FCC CLASS II PERMISSIVE CHANGE REQUEST LETTER

**RE: FCC Permissive II Change Request for Company: Swann Communications Pty Ltd,
FCC ID: VMISWIFIXTRCAM**

We are submitting an application for a class II permissive change to the FCC approval of the Company name: Swann Communications Pty Ltd, product description: Xtrem Wire Free Security Camera (FCC: **VMISWIFIXTRCAM**, Original Grant Date: 2020/10/20). The transmitter module itself has not changed. Here are the changes:

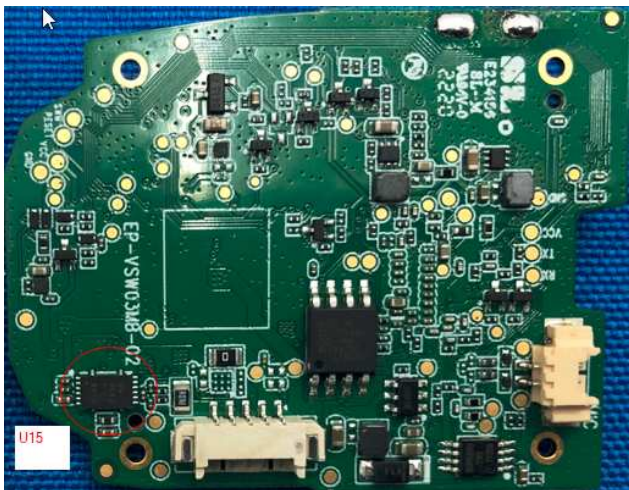
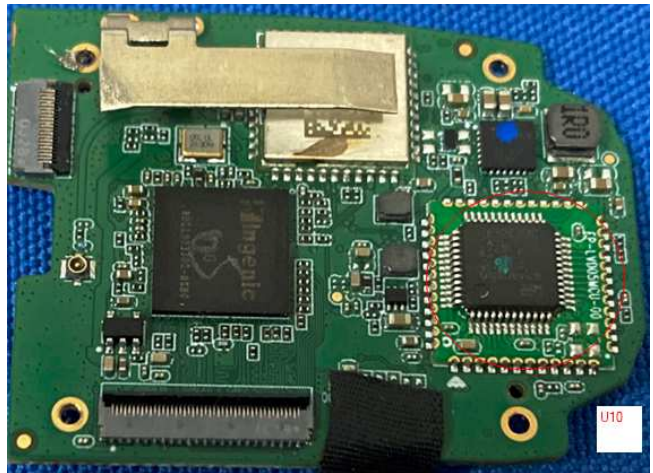
- 1) Changed the U10 from STM8K6U6 to GD32E230C8T6 as MCU
- 2) Changed the U15 from SON250X400X100P40-13 to SH366002R012RE as voltage regulator IC
